SUBDIVISION REPORT - CONCEPT

► FILE #: 10-SA-23-C		AGENDA ITEM #:	12
POSTPONEMENT(S):	10/5/2023	AGENDA DATE:	11/9/2023
SUBDIVISION:	MIDDLEBROOK GROVE		
APPLICANT/DEVELOPER:	HUBER PROPERTIES LLC		
OWNER(S):	Schubert Family Limited Partnership		
TAX IDENTIFICATION:	106 C A 02301, 00401, 004, 001	<u>View m</u>	ap on KGIS
JURISDICTION:	City Council District 3		
STREET ADDRESS:	1817 FRANCIS RD (0 Helmbolt Rd & 0 Old	d Amherst Rd)	
LOCATION:	East side of Helmbolt Rd, north side of F Amherst Rd	rancis Rd, west of O	ld
SECTOR PLAN:	Northwest County		
GROWTH POLICY PLAN:	N/A (Within City Limits)		
WATERSHED:	Ten Mile Creek		
APPROXIMATE ACREAGE:	16.82 acres		
► ZONING:	RN-2 (Single-Family Residential Neighbo	orhood)	
EXISTING LAND USE:	Single Family Residential		
PROPOSED USE:	Detached residential subdivision		
SURROUNDING LAND USE AND ZONING:	North: Single family residential, rural resider Residential Neighborhood) South: Single family residential, multi-family 1 (Single-Family Residential Neighborhood) Neighborhood) East: Single family residential, rural resident RN-1 (Single-Family Residential Neighborhood) West: Single family residential - RN-1 (Sing Neighborhood)	- AG (General Agricu

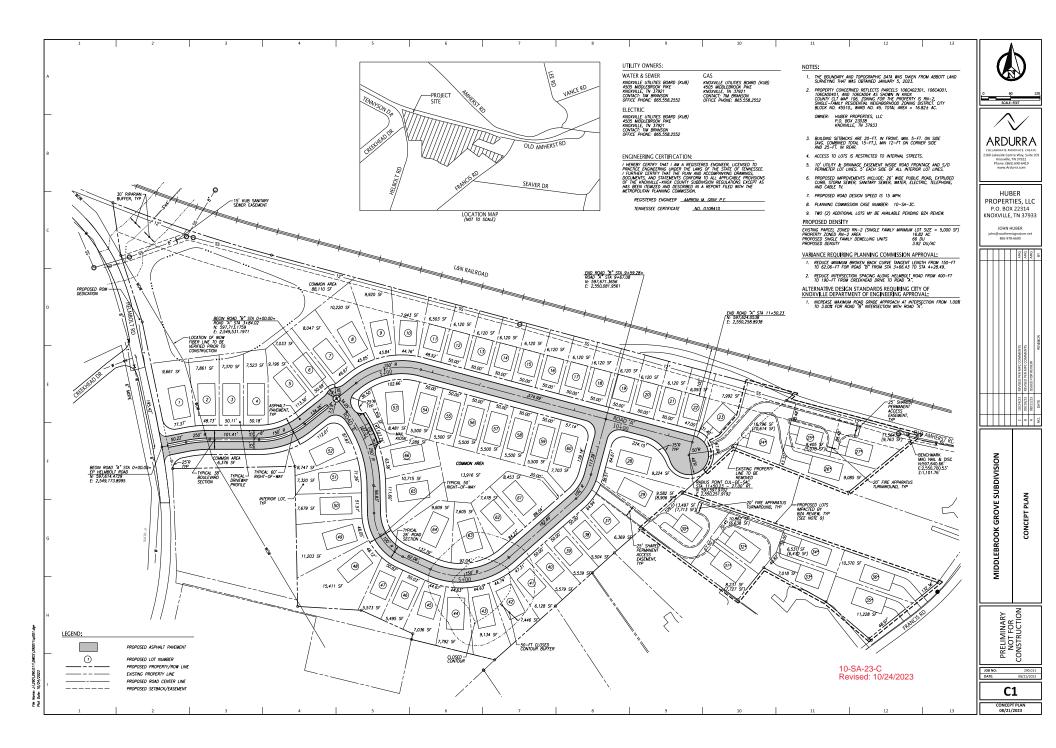
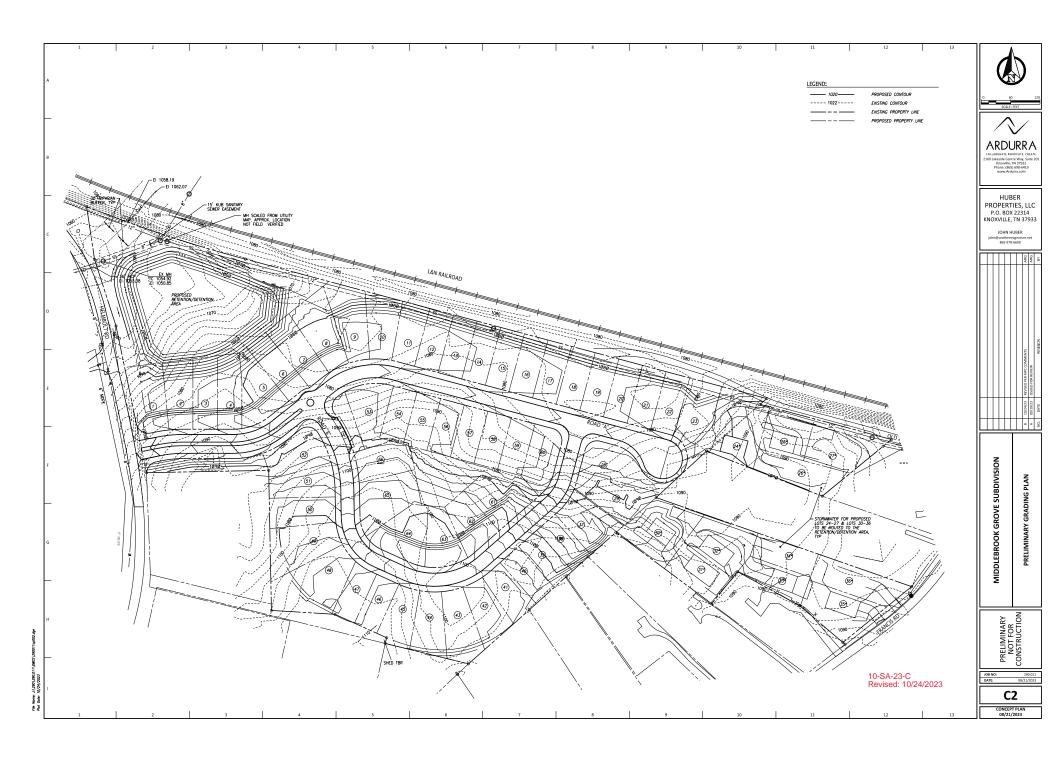
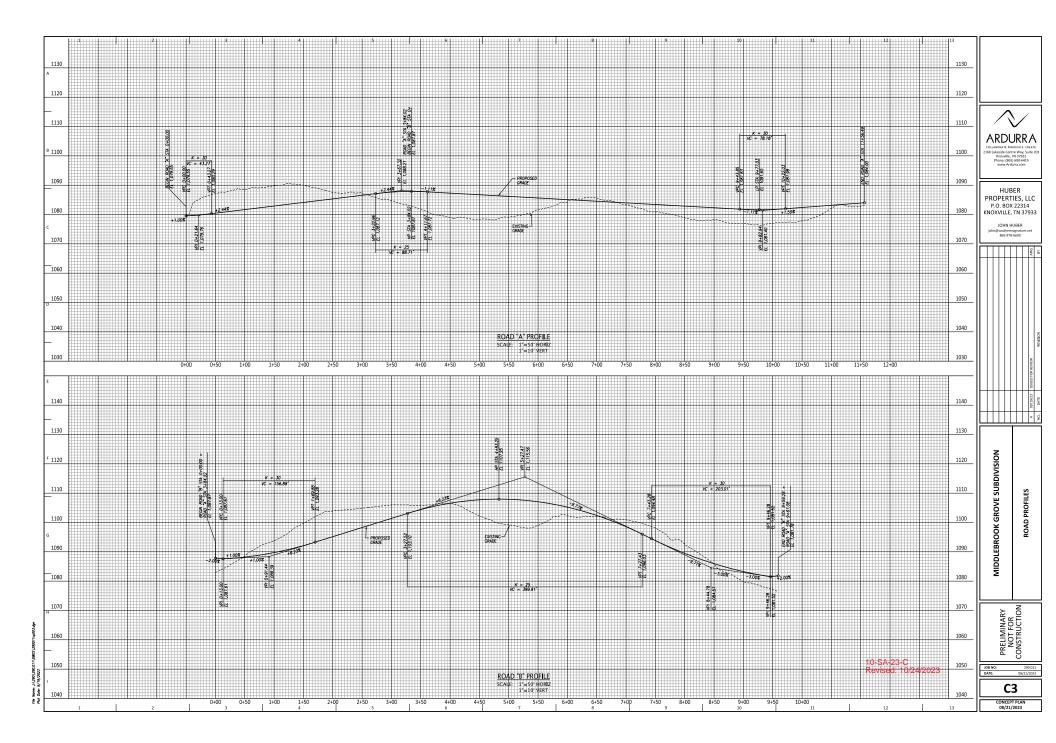
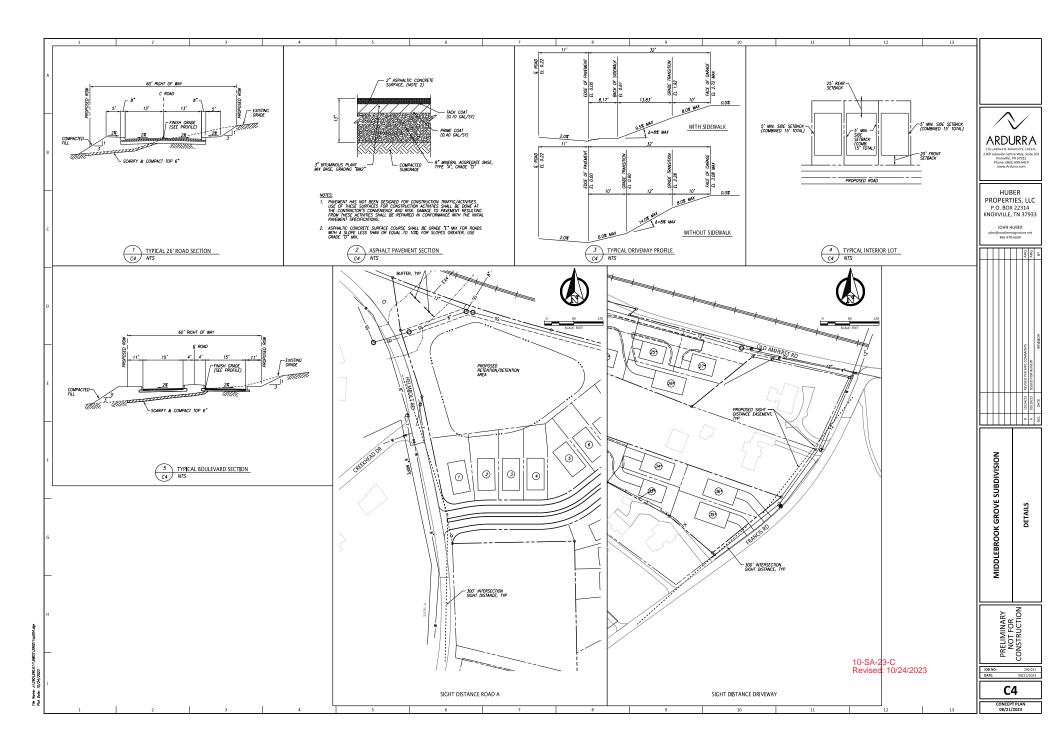
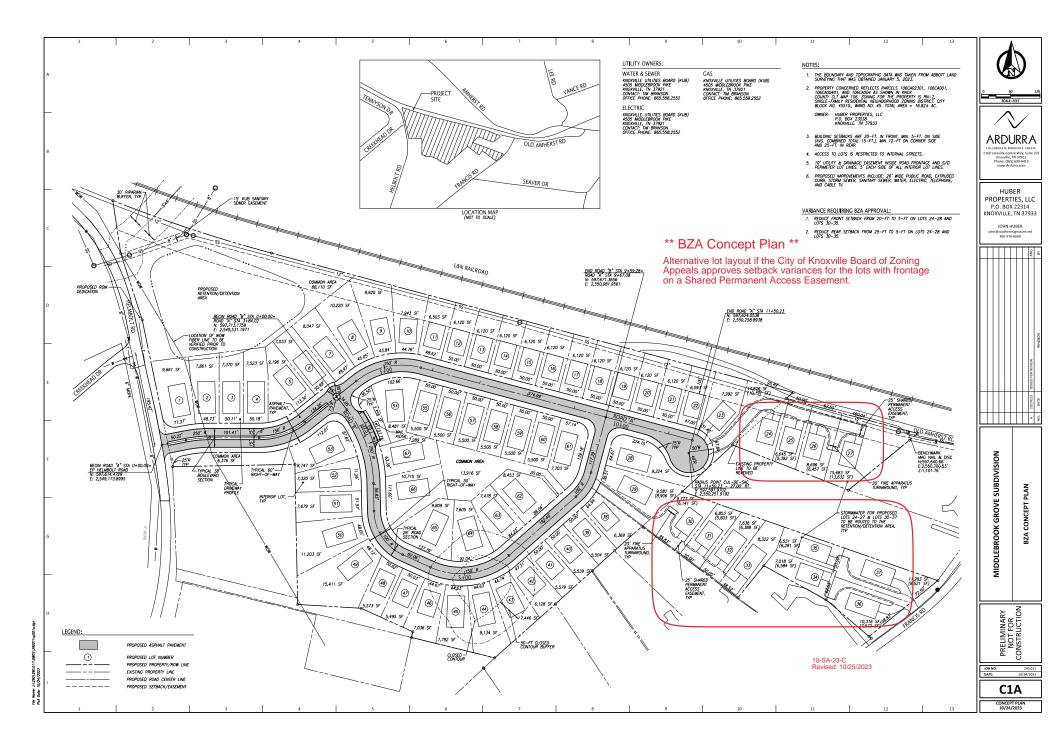
9. Revising the shared permanent access easement (SPAE) that crosses and/or provides access to lots 29-34 to comply with the SPAE standards in Section 3.03.D. of the Subdivision Regulations so that no more than 5 lots are served by the SPAE, including any lot that the SPAE crosses that has frontage on a road (lot 29). This SPAE currently serves 6 lots.

10. If the City of Knoxville Board of Zoning Appeals approves the setback variance requests proposed on the "BZA Concept Plan" (sheet C1A), Planning and Knoxville Department of Engineering staff may approve the lot layout and shared permanent access easement (SPAE) design, consistent with the approved variances and the standards of the City of Knoxville Zoning Ordinance and the Subdivision Regulations. The subdivision shall not exceed 67 lots for single-family dwellings.

This proposal is for a 66-lot detached residential subdivision on this 16.82-acre property. The applicant submitted an alternative lot design on plan sheet C1A, called BZA Concept Plan, which has 67 lots. Additional details regarding this alternative plan are below. The RN-2 zone requires a minimum lot size of 5,000 sqft and lot width of 50 ft. The proposed lot sizes range from 5,078 to 15,411 sqft, with most lots being between 5,500 to 8,000 sqft. The property was rezoned from AG (General Agricultural) to RN-2 (Single-Family Residential Neighborhood) in March 2023 (10-R-21-RZ).

An SPAE allows access for up to 5 lots, but this includes any lot with frontage on a public or private road that the SPAE crosses. Also, the frontage lot must also obtain access from the SPAE, unless the Knoxville Department of Engineering approves direct access to the street. Regardless, the lot with frontage counts toward the 5 allowed lots. The proposed SPAE that crosses lot 29 and provides access to lots 30 - 34 has 6 lots, including lot 29. One lot must be removed from this SPAE.

The setback variances the applicant has applied for are to reduce the front and rear setbacks to 5 ft so they function as side setbacks. The houses can be oriented toward the SPAE, regardless of whether BZA approves the variances. However, fewer houses can fit in these narrow portions of the development the setback variances are denied.
